## **KHNP Response to Issues - DCD Section 3.9.5**

Figure 2-1 Core support barrel lower flange flexure part

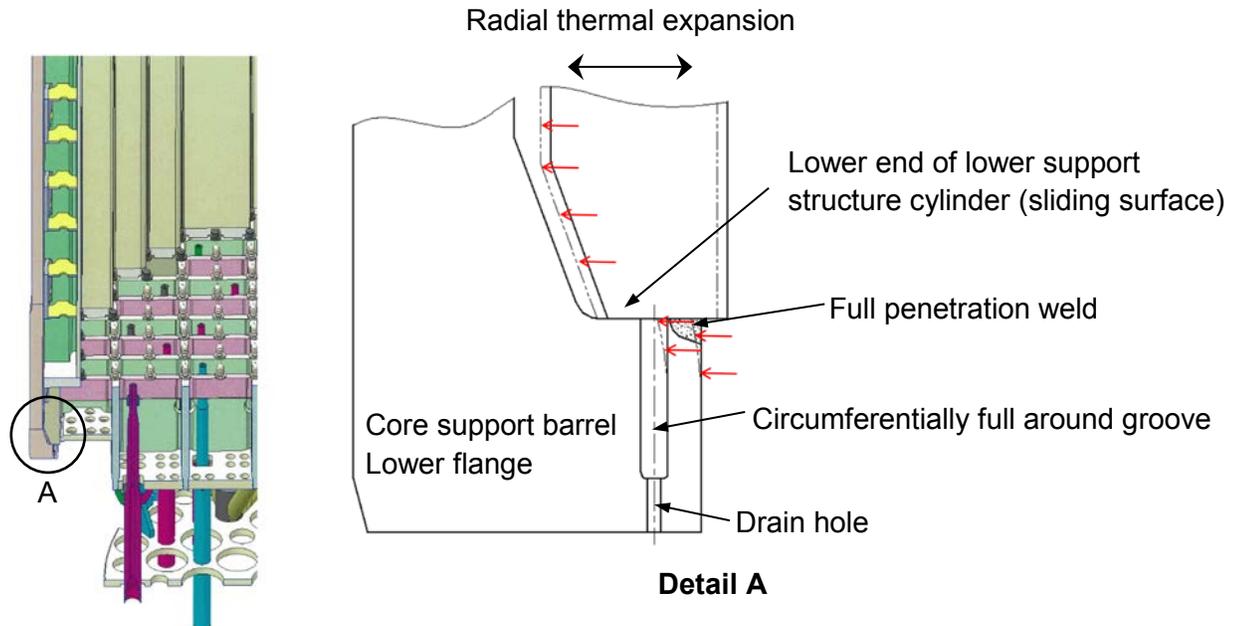
Based on the information provided in DCD Tier 2, Section 3.9.5.1.1 and Figure 3.9-9, it is not clear to the staff the configuration and geometry of either the lower flange of the core support barrel or the core support barrel welded flexural connection to the lower support structure. In addition, DCD Tier 2, Section 3.9.5.1.1 states that the core support barrel assembly is supported at its upper flange on the reactor vessel ledge. However, since the core support barrel lower flange is attached to the lower support structure by means of a welded flexural connection, it is unclear to the staff exactly which component(s) support the weight of the core and how much of the core support barrel and the core is supported at the reactor vessel ledge. DCD Tier 2, Section 3.9.5.1.1 also indicates that the lower support structure assembly is the primary component that supports the weight of the core, and Figure 3.9-8 shows that the lower

The configuration and geometry of the core support barrel welded flexural connection to the lower support structure are shown in Figure 2-1. The lower flange of the core support barrel is attached to the lower end of the lower support structure cylinder by a welded flexural connection. The inside part in the lower end of the lower support structure cylinder is welded circumferentially to the flexure part in the lower flange top of the core support barrel. The outside part of the lower end of the lower support structure cylinder just slides on the inside surface of the lower flange top of the core support barrel to accommodate the differential thermal expansion between the lower support structure and the core support barrel. As shown in Detail A of Figure 2-1, the bottom portion of the lower support structure cylinder moves on the top surface of the core support barrel lower flange in the radial direction only, but is restricted in the axial direction.

The lower support structure assembly does not rest on the clevis at the bottom of the reactor vessel, but on the lower flange of the core support barrel as shown in the above figure. The lower support structure directly supports the weight of the core and then transmits the load to the core support barrel lower flange. Finally, all the loads of the core support barrel assembly and the core are supported at the reactor vessel ledge. The load path is shown in Figure 2-2.

Figure 3-1 Flanges of core support barrel

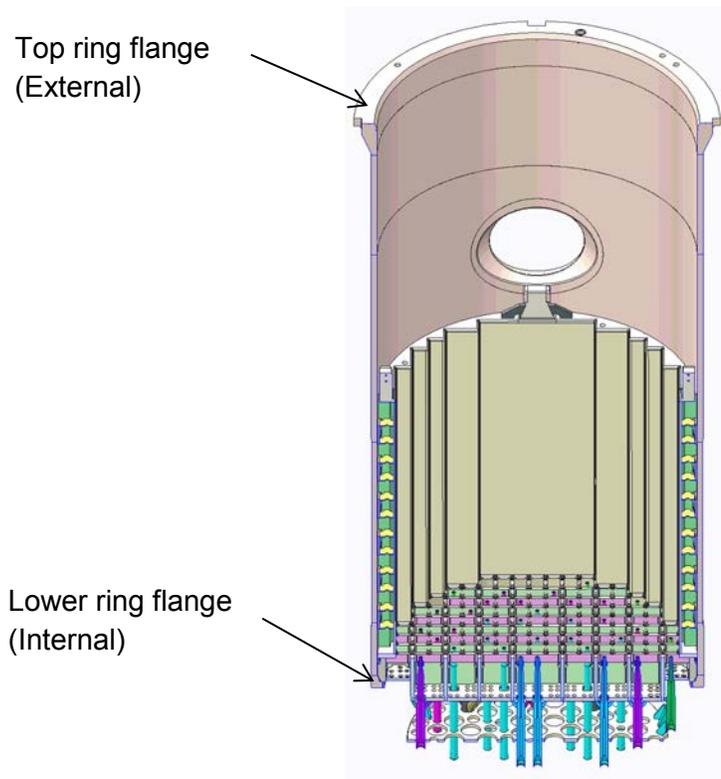
DCD Tier 2, Section 3.9.5.1.1.1 describes the core support barrel as a right circular cylinder including a heavy external ring flange at the top end and an internal ring flange at the lower end. It is unclear to the staff which component is the top ring flange and which component is the lower ring flange in DCD Tier 2, Figure 3.9-9. The applicant is requested to provide a more detailed drawing of the core support barrel that identifies these two ring flanges. In addition, the applicant is requested to describe the function of these two ring flanges and if they support any load during normal and accident conditions.

The configuration related to the top and lower ring flange of the core support barrel is shown in Figure 3-1.

The core support barrel assembly is supported at its upper end by the top ring flange of the core support barrel, which rests on a ledge in the reactor vessel. The lower ring flange of the core support barrel supports, secures, and positions the lower support structure including the core.

Figure 4-1 Core support barrel snubber

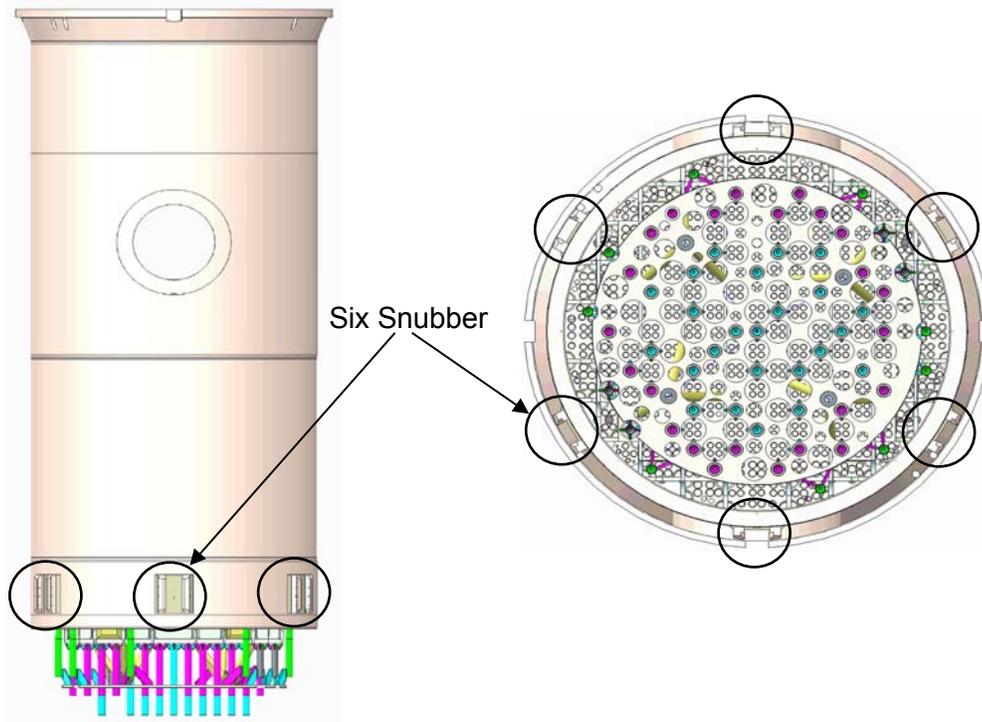
- c. It appears to the staff that there are four snubbers on the core support barrel as shown in DCD Tier 2, Figure 3.9-9, however, DCD Tier 2, Section 3.9.5.1.1.1 states that there are six snubbers. The applicant is requested to clarify this discrepancy.

- b. The snubber assembly does not support any weight of the core support barrel and the core. Only radial and axial expansions of the core support barrel are accommodated, but excessive lateral and torsional movement of the core support barrel is restricted by six snubbers.
- c. Though it appears that there are four snubbers on the core support barrel as shown in DCD Tier 2, Figure 3.9-9, the core support barrel actually has six snubbers as shown in Figure 4-1. The left figure is a front view of the core support barrel assembly and the right figure is a bottom view of the core support barrel assembly. The left figure presents only three snubbers while another three snubbers are located at the opposite side.

Figure 4-2 Fuel locating pin and socket head cap screw

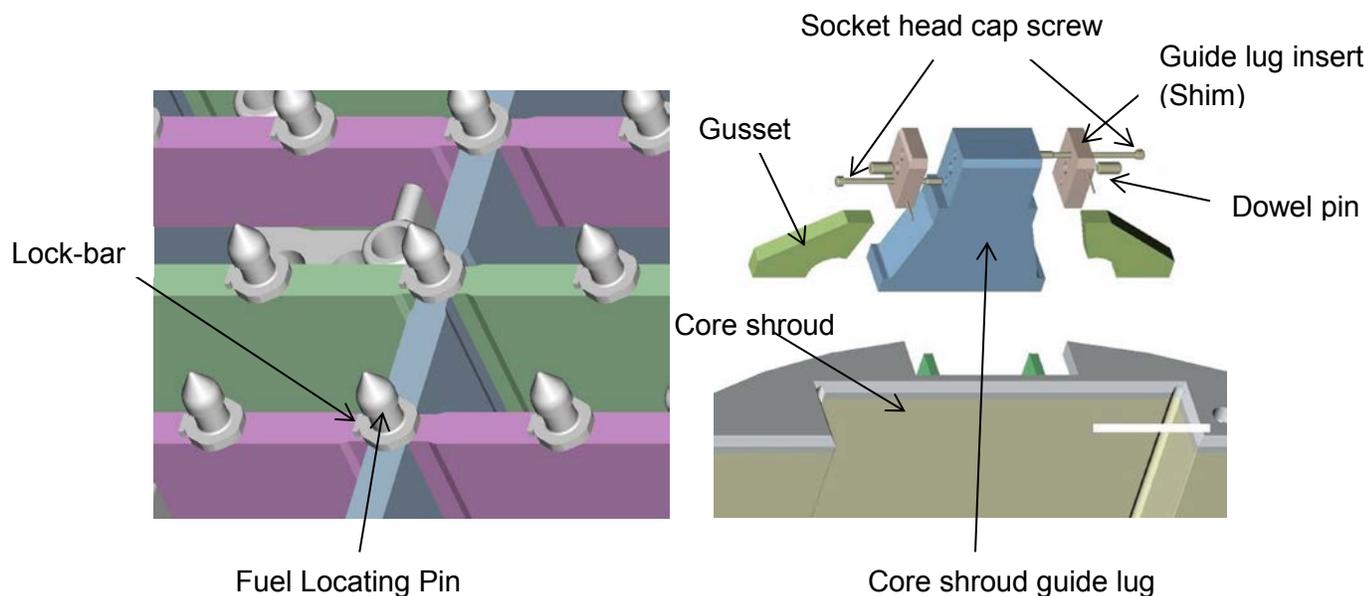
- e. The applicant is requested to clarify if threaded structural fasteners are used in other reactor internals components than those listed in item (d) above.

- e. The fuel locating pins and the socket head cap screws are used as threaded structural fasteners in reactor internal components as shown in the following figure. The fuel locating pins are attached to the top of the lower support structure beams to provide orientation for the lower ends of the fuel assemblies. The fuel locating pins are secured by tack weld to the lock-bar. The socket head cap screws are used to attach the guide lug inserts (shims) to the core shroud guide lug. Four guide lugs, spaced 90 degrees apart, protrude vertically from the top of the core shroud and engage in corresponding slots in the UGS fuel alignment plate to provide proper alignment. The fuel locating pins and socket head cap screws pertaining to the reactor internals are designed in accordance with Section III, Subsection NG of the ASME Code.

Figure 6-1 Lower support structure/ICI assembly

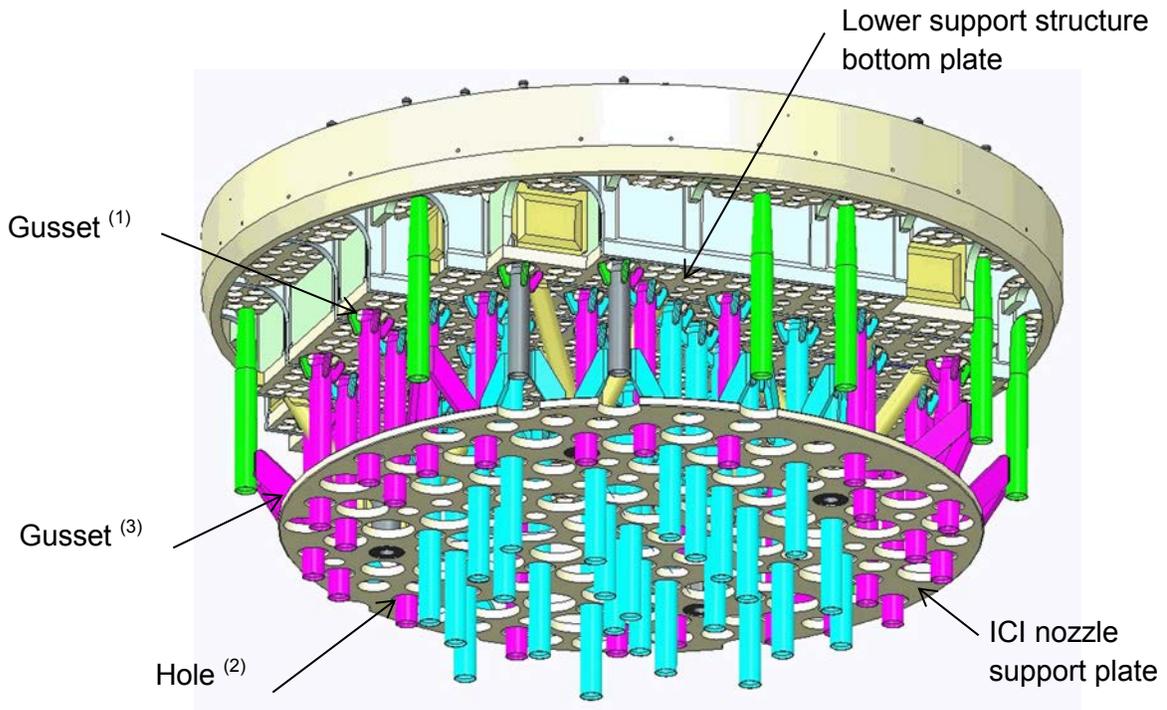
- a. The interface between the ICI nozzle to both bottom plate and ICI nozzle support plate
- b. The location, number, and function of the support columns, and their interfaces to the bottom plate and ICI nozzle support plate as shown in Figure 3.9-11
- c. The function of the gusset as shown in DCD Tier 2, Figure 3.9-11
- d. The main support beam configuration (with support from a drawing), as well as how the cross beams are connected to the secondary support beam as shown in DCD Tier 2, Figure 3.9-11

- a. The upper part of the ICI nozzle is welded to the lower support structure bottom plate by gussets<sup>(1)</sup>. The lower part (central) of the ICI nozzle is welded to the hole of ICI nozzle support plate<sup>(2)</sup> and the lower part (peripheral) of the ICI nozzle is welded to the ICI nozzle support plate by gussets<sup>(3)</sup> as shown in Figure 6-1.

Figure 8-1 Core Shroud Assembly

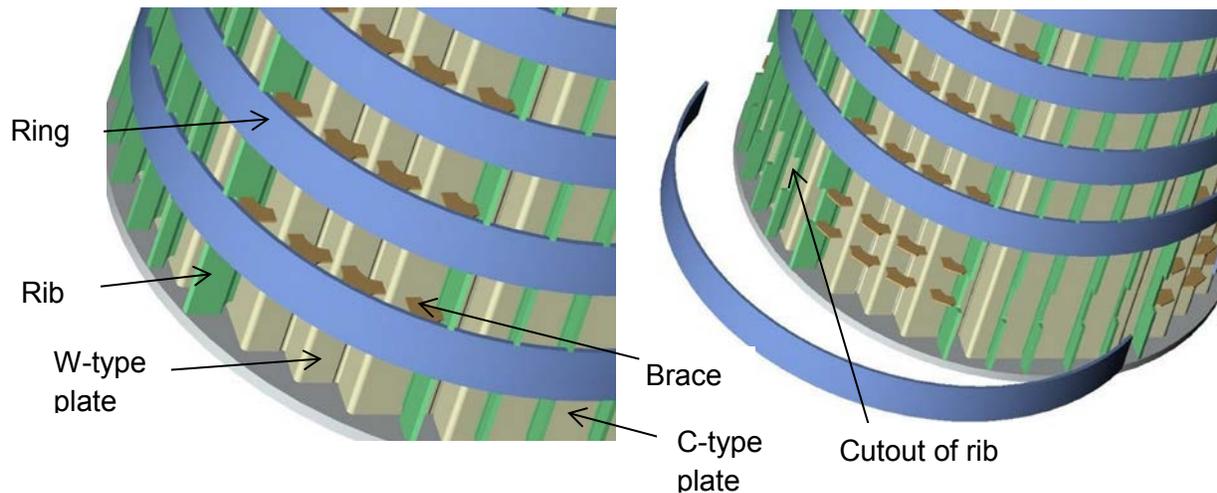
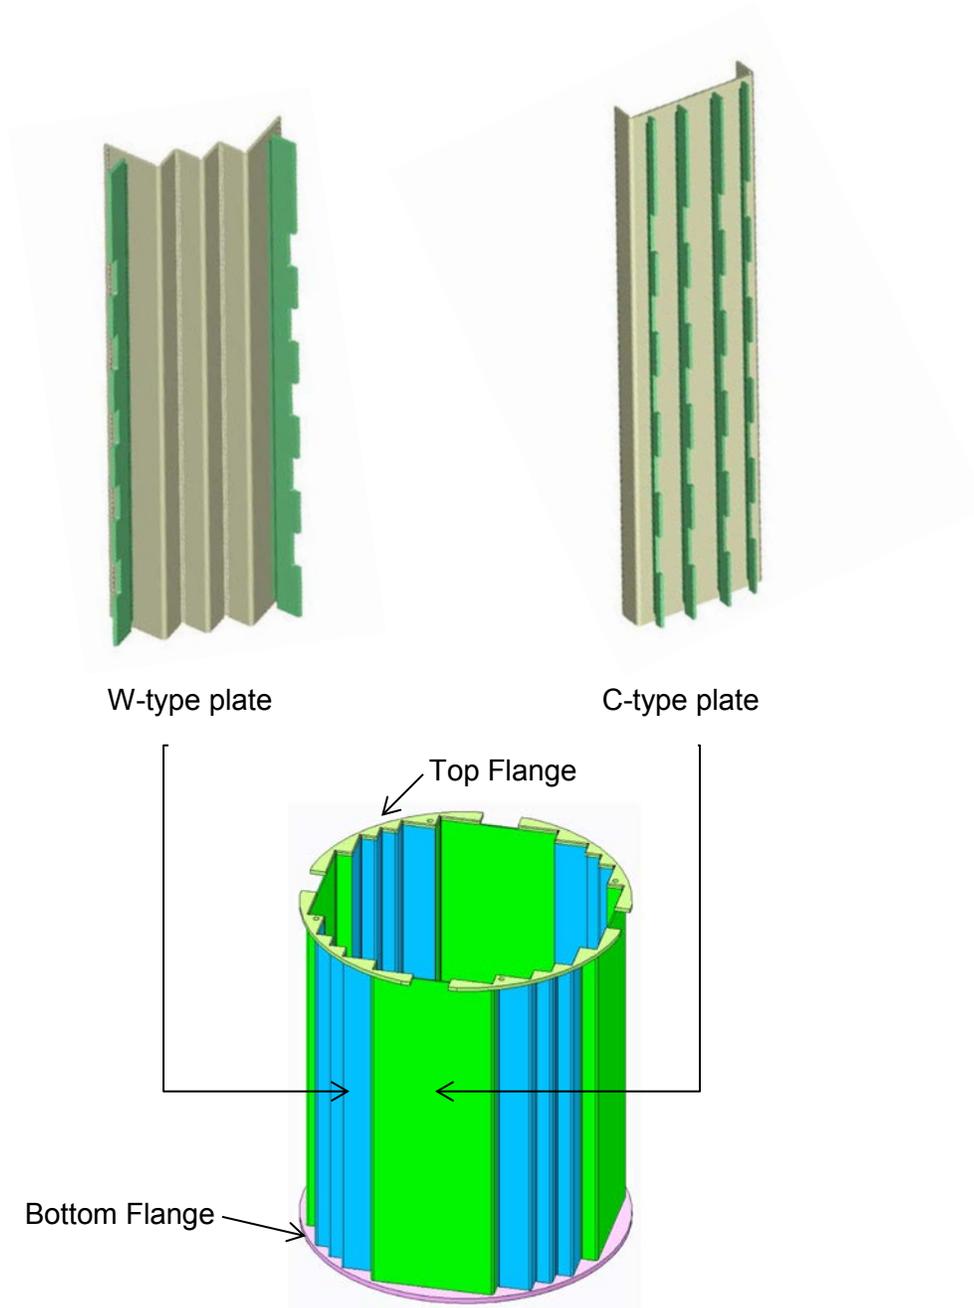
It is unclear to the staff based on this figure how the circumferential rings are attached to the vertical plates by means of full length welded ribs and horizontal braces. Therefore, the applicant is requested to describe how the circumferential rings are attached to the vertical plates. In addition, DCD Tier 2, Section 3.9.5.1.1.3 does not describe how the core shroud vertical plates are attached to each other. Therefore, the applicant is requested to provide this description. If structural fasteners are used, the applicant is requested to provide description on how these fasteners are designed and qualified under the intended operating life of the plant.

The upper and lower portions of the circumferential rings are attached to the cutout of the rib by weld as shown in in Figure 8-1. The ribs are attached to the vertical plates by means of a full length weld axially.

The core shroud vertical plates consist of four W-type plates and four C-type plates as shown in Figure 8-2. The W and C-type plates are welded on the bottom and top flanges. The W and C-type plates are then attached to each other by means of a full length weld axially. There are no structural fasteners used to attach the core shroud vertical plates.

Figure 9-1 CEA guide tube assembly

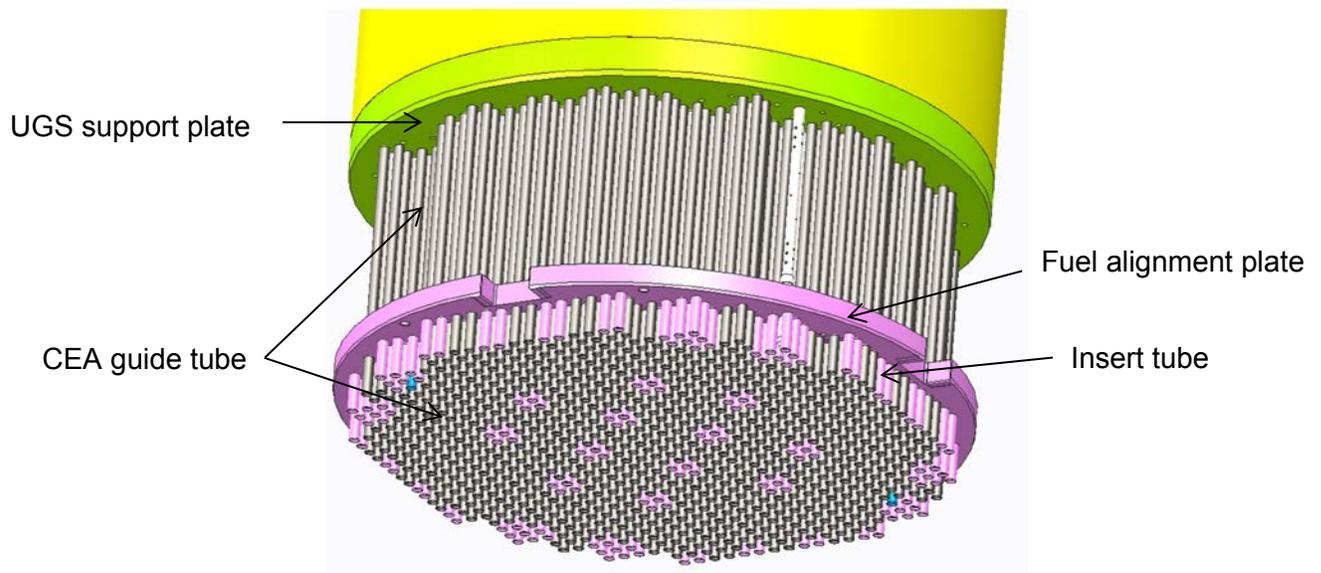
Based on the information provided in the DCD, the staff does not consider the description of the UGS barrel assembly and its subassemblies to be sufficient. Specifically, the applicant is requested to provide additional or revised drawings of the UGS barrel assembly that show the interface between the UGS support plate and control element guide tubes, and the interface between the control element guide tubes and the fuel alignment plate. Additional, to assist the staff's review, the applicant is requested to provide a cross-sectional drawing of the control element guide tubes. The applicant is also requested to describe the following:

- a. The interface between the UGS support plate and control element guide tubes, and the interface between the control element guide tubes and the fuel alignment plate. Specifically, how are the control element guide tubes rolled in the holes of the UGS support plate and fuel alignment plate?
- b. What loads, during both normal operation and accident conditions, do the control element guide tubes experience?

- a. The control element guide tubes (Figure 9-1) are attached to the top of the UGS support plate and the bottom of fuel alignment plate by a full around weld after tube rolling. The tube rolling for the control element guide tube and the UGS support plate (or fuel alignment plate) is performed by a hydraulically operated rolling machine. The section view of the CEA guide tube interface area is shown in Figure 9-2 and the insert tube interface area is shown in Figure 9-3. The inner barrel assembly is inserted into the upper guide structure and welded at the flange by a flexure weld as shown in Figure 9-4. The CEA shroud consists of the shroud tube and web plate. Four web plates are full penetration welded axially on the outside surface of the shroud tube and equally spaced circumferentially as shown in Section B-B of Figure 9-4.

Figure 9-4 UGS assembly

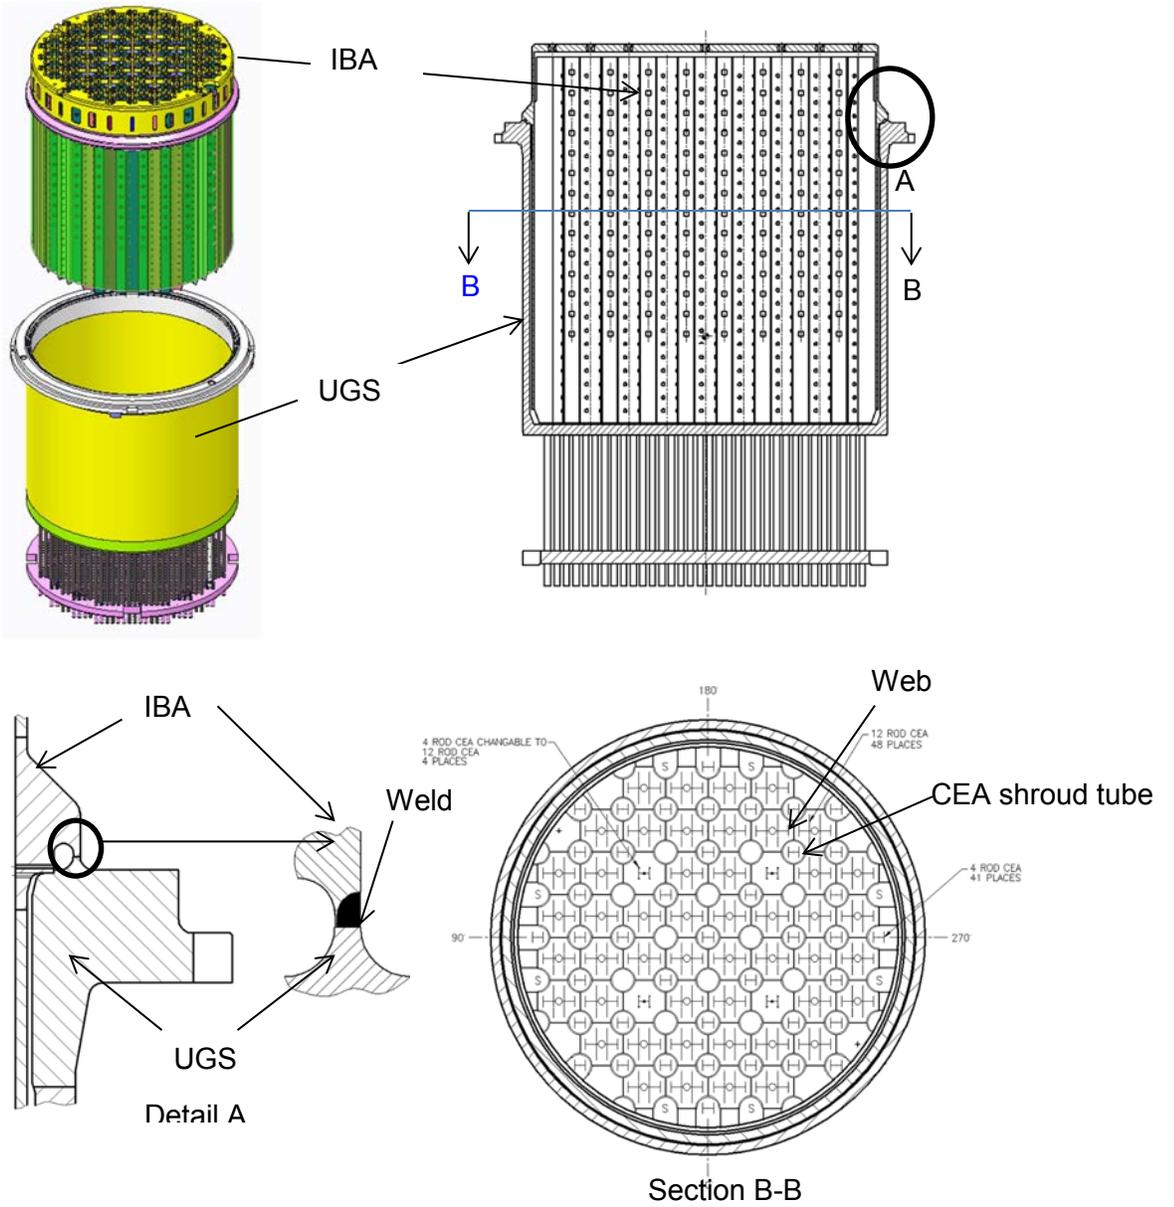
- c. How is the structural integrity of the control element guide tubes maintained throughout its design life under both normal and accident conditions?
- d. How do the control element assembly and its corresponding drive shaft move in and out of the control element guide tubes into the inner barrel assembly? What is the position of the control element assembly relative to the inner barrel assembly and control element guide tubes when at its fully withdrawn position?

- d. The control element assembly and its corresponding drive shaft move in and out of the control element guide tubes into the inner barrel assembly by CEDM latch driving, magnetic jack type, described in DCD Tier 2, Section 3.9.4 (CEDM). The lower end of the control element assembly is positioned near the top of the active core within the fuel assembly when the CEA's are in the fully withdrawn position as shown in Figure 9-5. In this position, the four and twelve rods of the CEA are inside of the CEA shroud of the inner barrel assembly as shown in Section B-B of Figure 9-4.
